High-voltage cable routing

ArgonCube 2x2 Cryogenics Meeting on July 12, 2021

Latest CAD model for High-voltage feedthrough and high-voltage filter box from collaborators

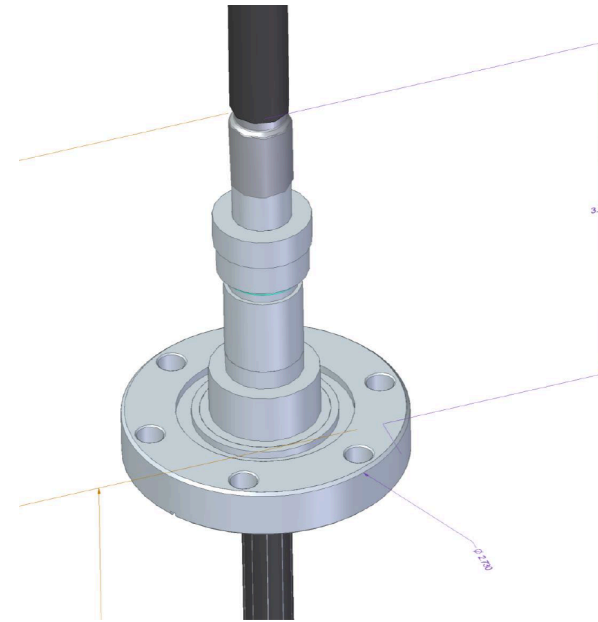
- Questions:
 - What's the red cylinder (marked with red arrow) above the flange?
 - How the cables must be connected to the filter box? Is this the cable that we are going to determine the length?
 - What are the limitations that we must be aware of to route cables? (e.g. cable bending radius, a preferred location of filter box, length limitation with cable, etc.)

The 24" long by 2" diameter cylinders will not be in your version. They are HV adapters which go from polymer cable to metal cable and get replaced by the terminations in the filter. This cable will go from above the Conflat to the filter without any interruptions. (The bend may start after the strain relief at the Conflat).

At SLAC, we just make one large arc from the Conflat to the filter. The reason for the 12" minimum bend radius is to keep the plastic inner shield (Layer 3) in contact with the insulation (Layer 2). When just a single braid is used, this can be tighter.

Shown is the HV feedthrough for Module Zero and ND
(It is a 2.75" Conflat flange with about 4" of compression tubes and strain reliefs above)
Please permit room for a gentle radius on the cable above this (12" radius should be fine above the rigid 4" section)

Proposed layout @MINOS

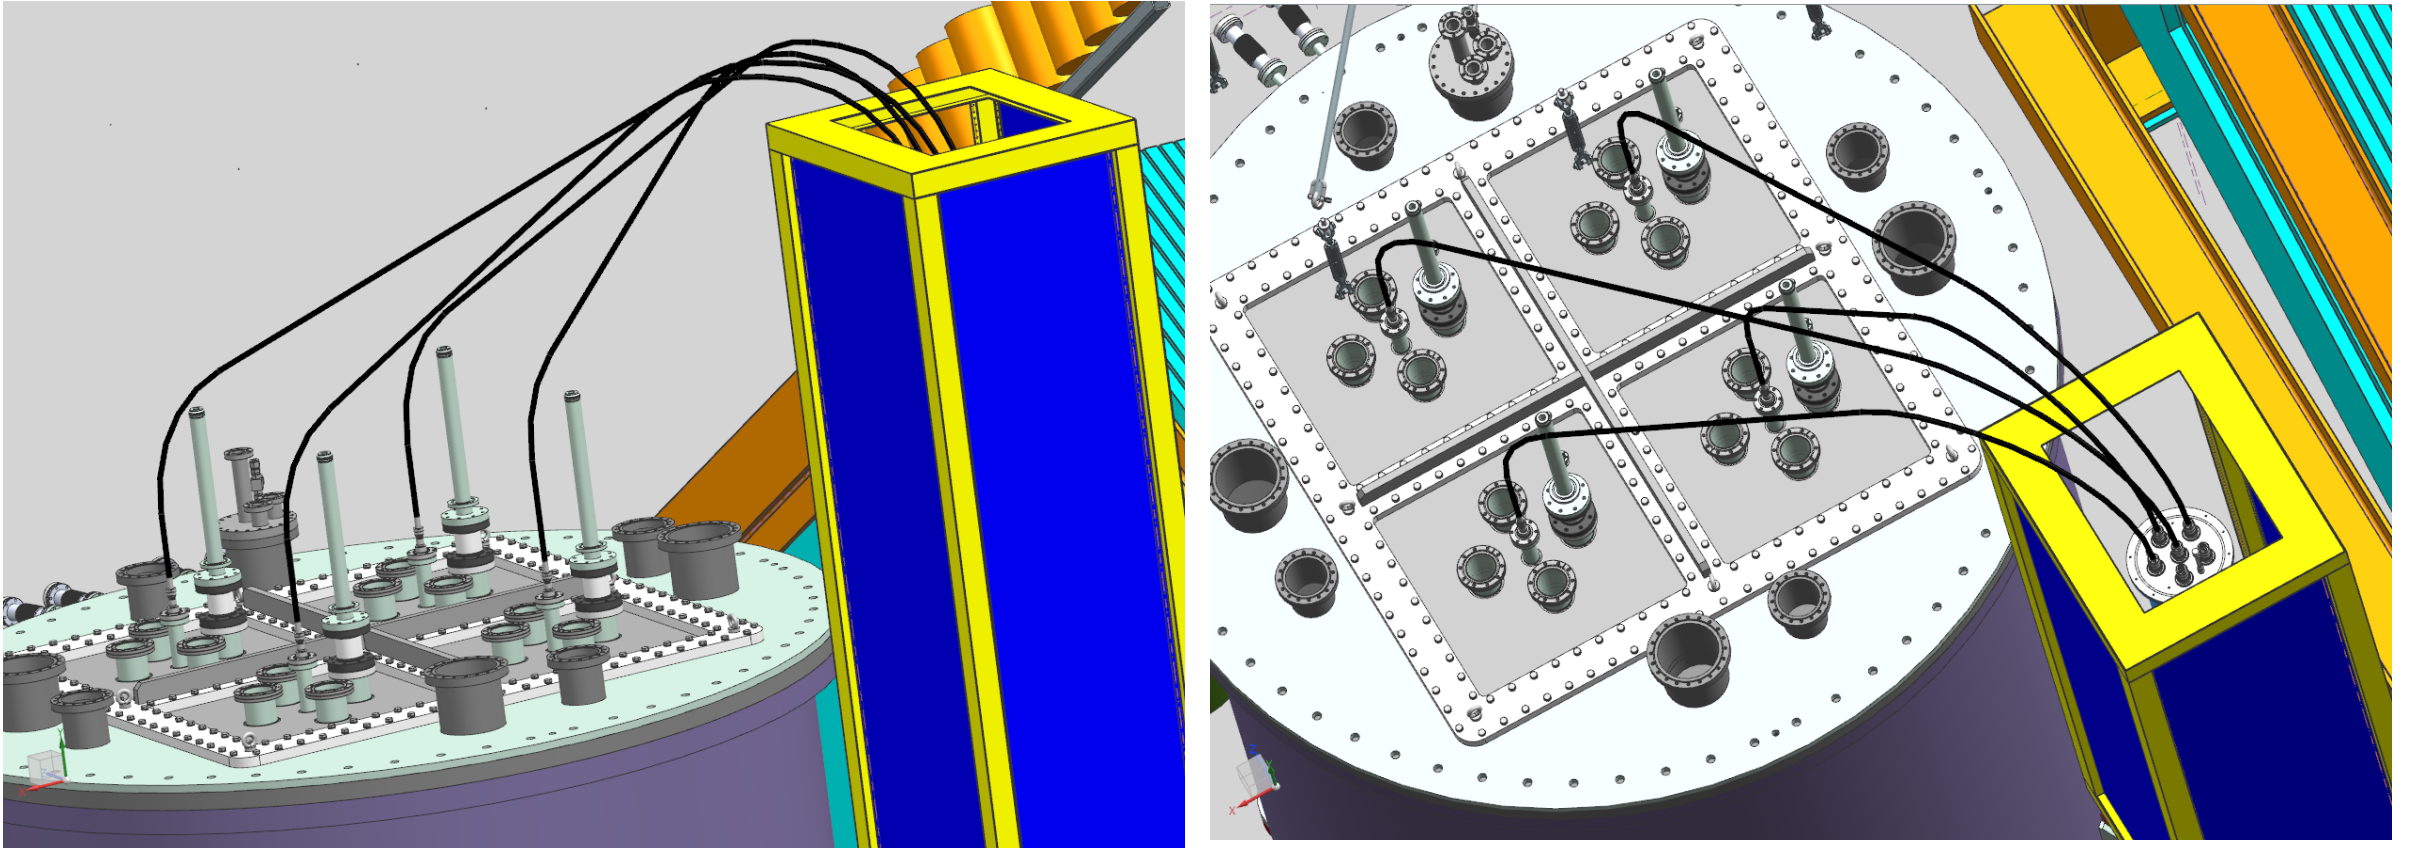
Weight of filter box: 30 kg (by Igor Kreslo)

Cable Length (Ordered by length): **127" (3226 mm)**, 118" (2998 mm), 108" (2744 mm), 97" (2464 mm)

Proposed layout @LArTF

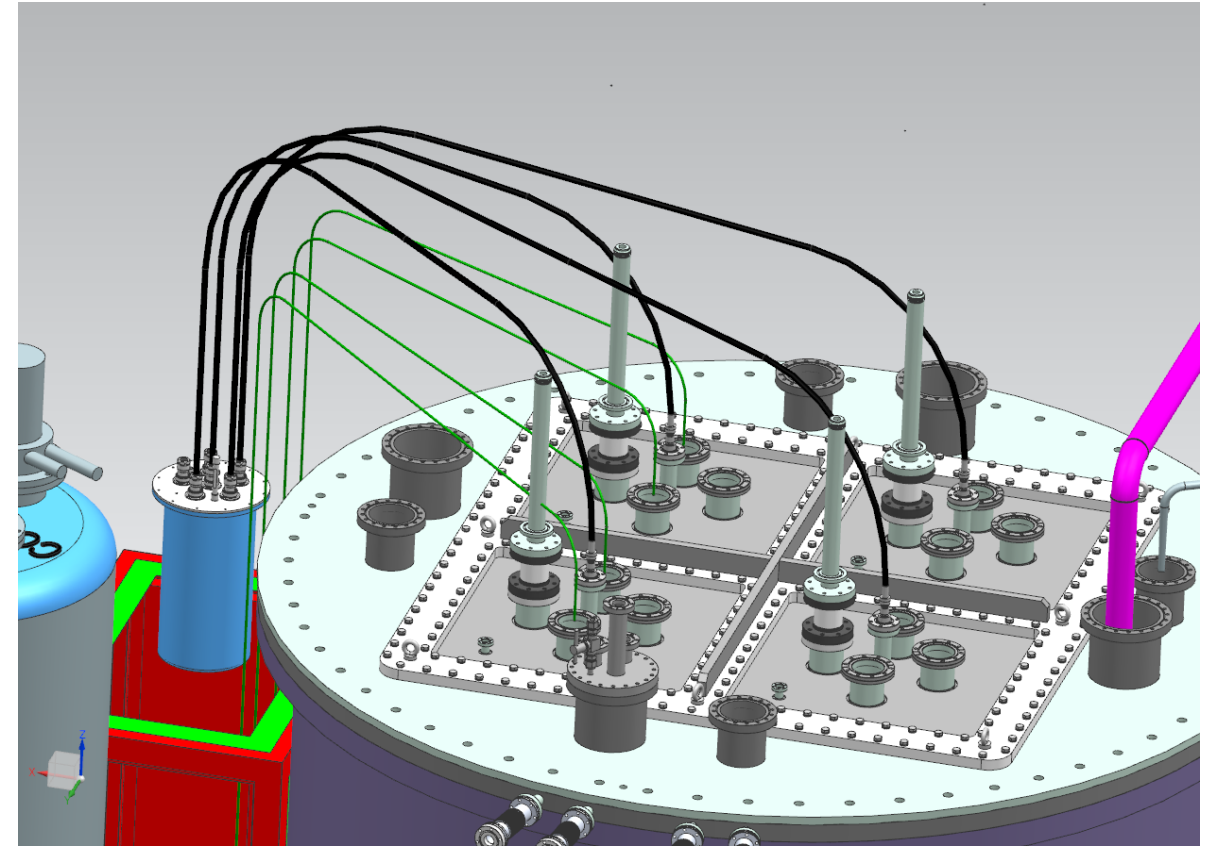
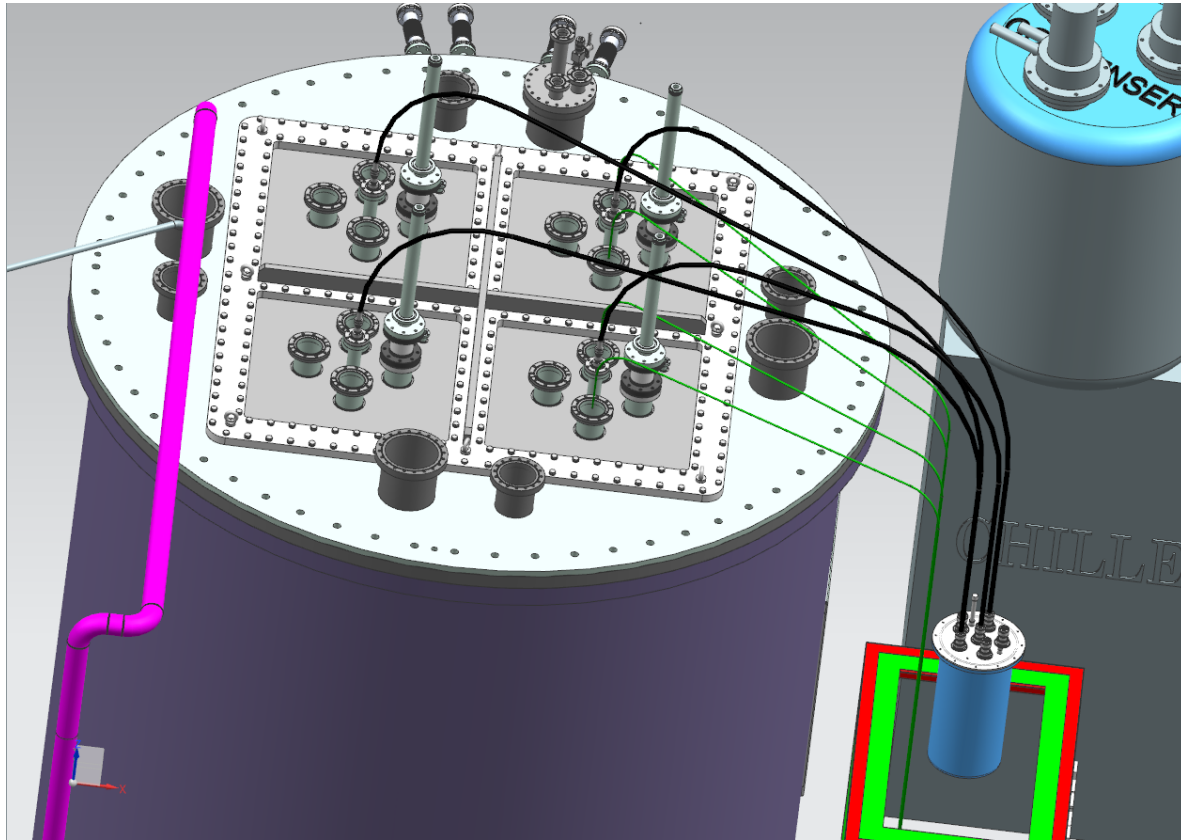
Weight of filter box: 30 kg (by Igor Kreslo)

Cable Length (Ordered by length): 119" (3023 mm), 110" (2794 mm), 100" (2540 mm), 87" (2210 mm)
